**RE: Stormwater Management Plan Modification
Avery County C & D Landfill Expansion
NC Solid Waste Permit No. 06-03**

On behalf of Avery County, Richardson Smith Gardner & Associates (RSG) is hereby submitting two (2) copies of the **enclosed** modification¹ to the stormwater management plan for the expansion of the construction and demolition debris (C&D) landfill disposal area in Ingalls, North Carolina.

As you may recall², there was a potential impact to a gas line that runs along the southern portion of the property in the proximity of Sediment Basin No. 4. Following a field locate by Piedmont Natural Gas (Piedmont), the basin required modification to provide buffer from this gas line for safety purposes. RSG coordinated this modification with Piedmont to fit the revised Basin No. 4 between the landfill and their proposed easement. Therefore, we have included revised calculations for the sediment basin and drawing revisions (**attached**) to the Waste Relocation and Site Improvements³ project previously submitted.

SHEET NO.: DRAWING NO.: 4 S3

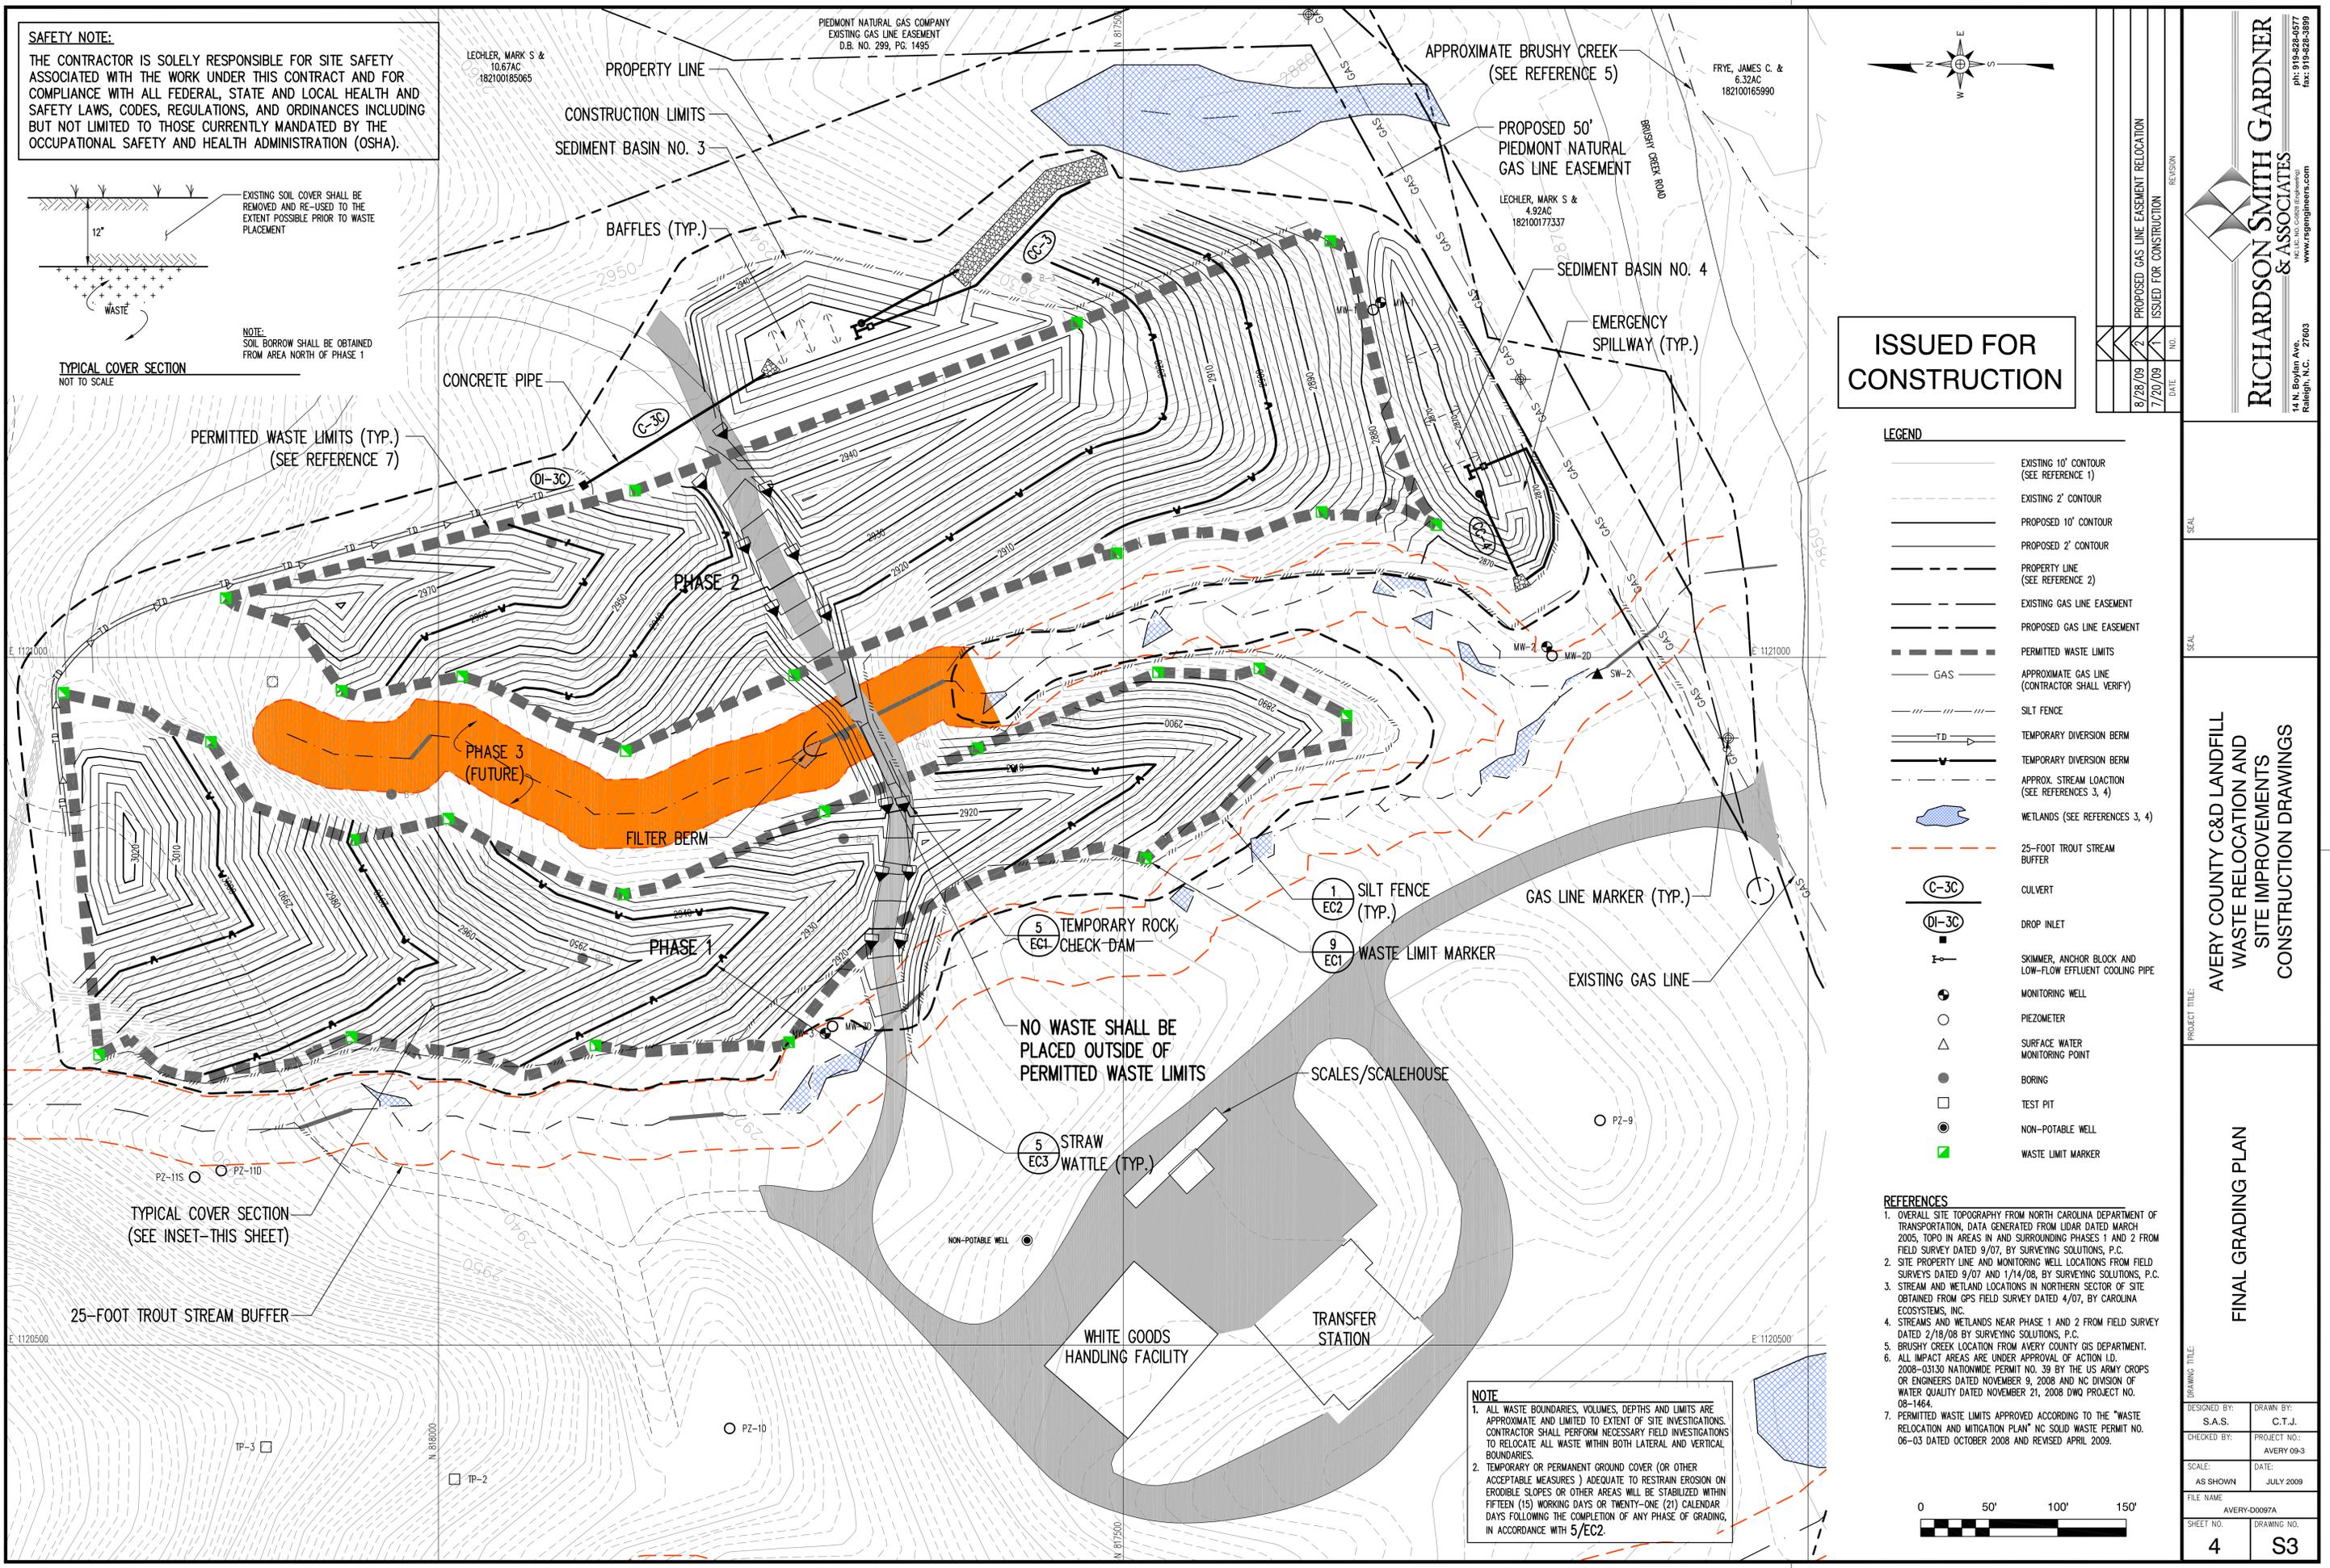
PROPOSED GAS LINE EASEMENT RELOCATION	REVISION
ISSUED FOR CONSTRUCTION	NO.
8/28/09	2
7/20/09	1
DATE	NO.
